**SUBJECT:** R.E. Ginna Nuclear Power Plant  
Docket No. 50-244

**Supplemental Response to Requests for Additional Information Regarding  
Topics Described by Letters Dated August 24, 2005 and October 28, 2005**

ATTACHMENT 2  
RESPONSES TO NRC RAIs 2, 3, 5 REGARDING POST-LOCA LONG-TERM COOLING  
OCTOBER 28, 2005

ATTACHMENT 3  
RESPONSES TO NRC RAIs REGARDING LOCA ANALYSES  
AUGUST 24, 2005

**Figure 4 Small Break LOCA - 4-Inch Break RCS Depressurization Without Operator Actions**

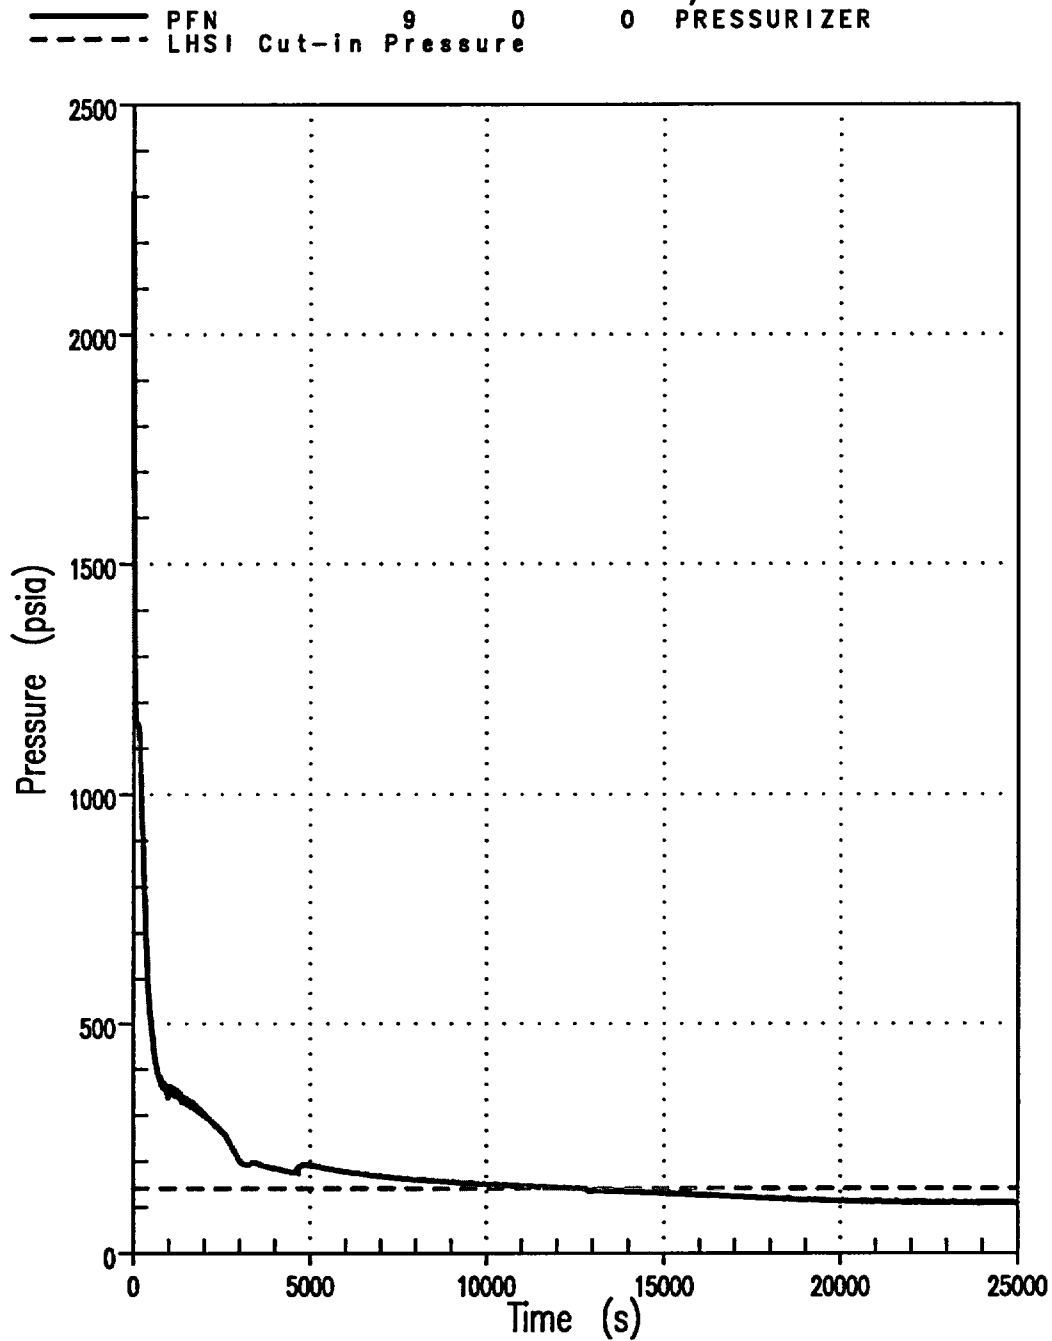
3. Provide information to show that for the largest break that does not actuate upper plenum injection (UPI) (where a cooldown is required) that there is sufficient time to perform this function given an appropriate precipitation time based on consideration of the four items in item 1 above.

The Small Break LOCA Boric Acid Analysis was based on calculations that used a time-varied mixing volume and core boil-off extracted from extended Ginna NOTRUMP Small Break LOCA Evaluation Model computer runs. A 4 inch break was selected since the Ginna EPU NOTRUMP Small Break Post-LOCA Cooldown Analysis (discussed in the next section) showed that a 4 inch break or greater will depressurize the RCS to RHR cut-in pressure without operator actions prior to reaching the boric acid atmospheric solubility limit. The RCS pressure versus time for a 4 inch break is given in Figure 4. The modeling features of these runs were as follows:

**Figure 7 Small Break LOCA Boric Acid Concentration Analysis - Vessel Boric Acid Concentration / Boiloff and Dilution Flow versus Time**

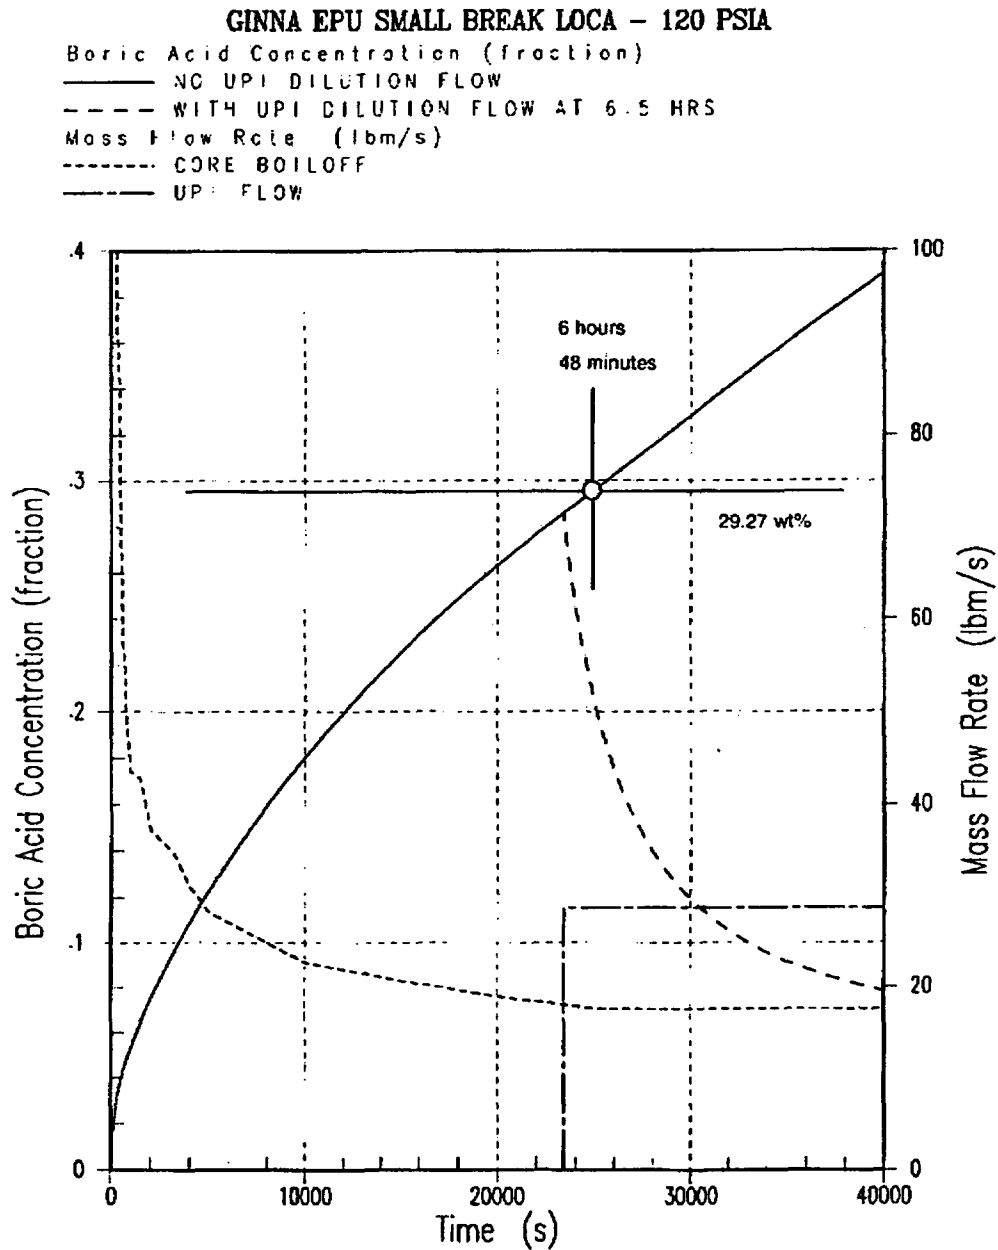
2. Small breaks were not addressed. The boric acid concentration for the limiting SBLOCA needs to be evaluated. Provide a summary of the results to show that the boric acid concentration is not sufficient to cause precipitation should the operators inadvertently depressurize the reactor coolant system (RCS) in a rapid manner.

The results of the small break boric acid precipitation calculations are shown in Figure 7. As seen in Figure 7, for small breaks where delayed RCS depressurization would occur, the boric acid solution will not approach the solubility limit until approximately 6 hours, 48 minutes after the break. If the RCS is depressurized through operator action to below 140 psia, UPI using the RHR (low head SI) pumps will initiate and this will provide immediate core flushing flow. Cooldown/depressurization calculations show that operators could depressurize the RCS to less than 140 psia long before 6 hours, 48 minutes. Figure 7 also shows core boil-off, SI dilution flow, and the rate of dilution of core region once dilution flow is initiated.

Figure 1.1 - Pressurizer Pressure

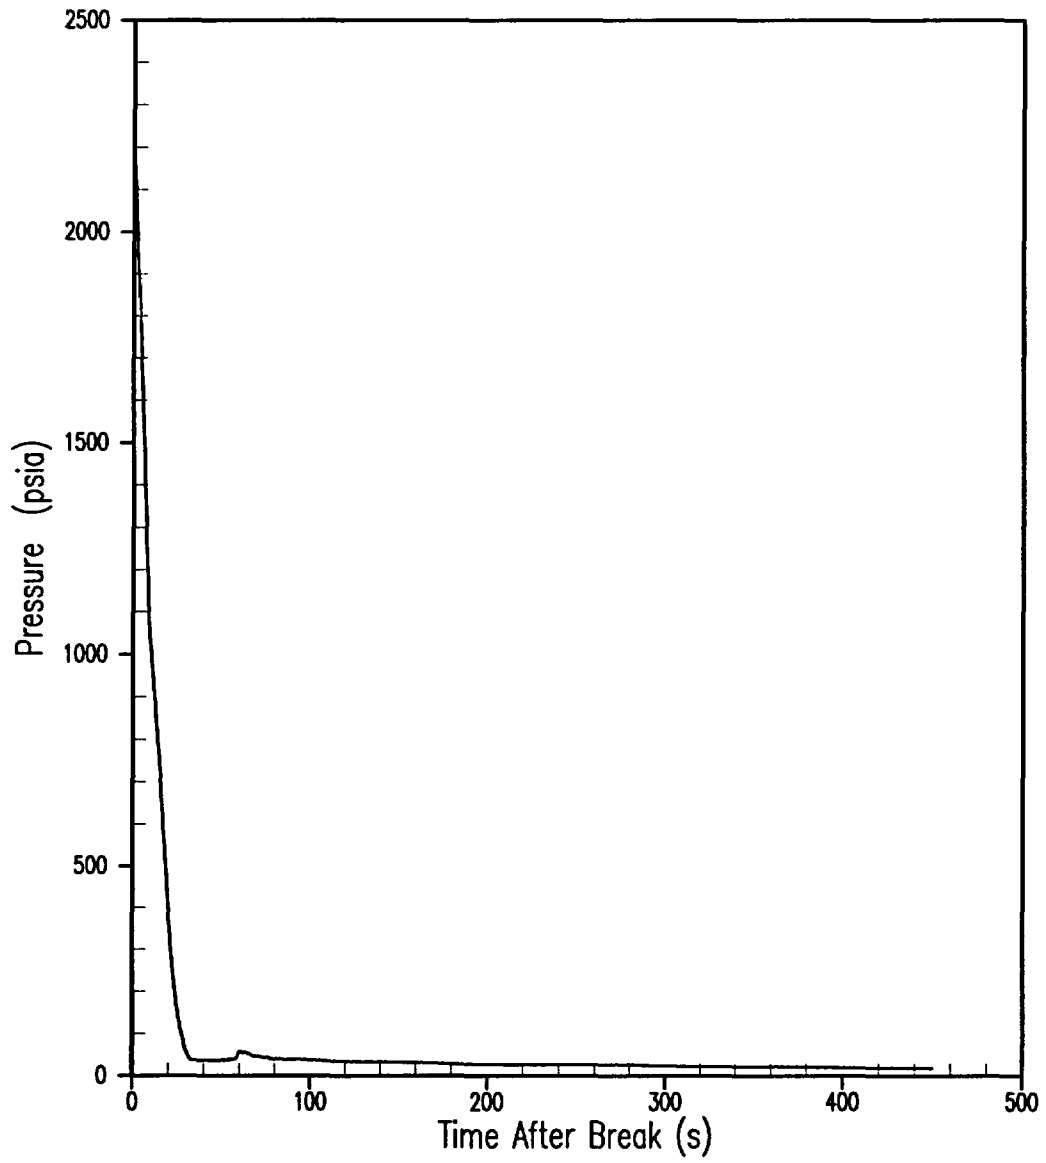
Additional analysis results are also required for the best-estimate large-break LOCA analysis. Only the PCT plot for the hot rod and hot bundle were provided for the limiting break.

Provide the complete analysis results including all of the key major response parameters. Also, did the analysis include downcomer boiling effects and what was the worst single failure if downcomer boiling occurs? What containment pressure was assumed?

Figure 1.1 is a plot of the pressurizer pressure throughout the transient. Figure 1.2 is a plot of the mass flow rate through the split break, and Figure 1.3 of the void fraction in both the intact and broken loop pumps. Figure 1.4 is a plot of the vapor flow rate at the top of the core for the first 20 transient seconds, and Figure 1.5 a plot of the total flow rate at the bottom of the core for the same time period.
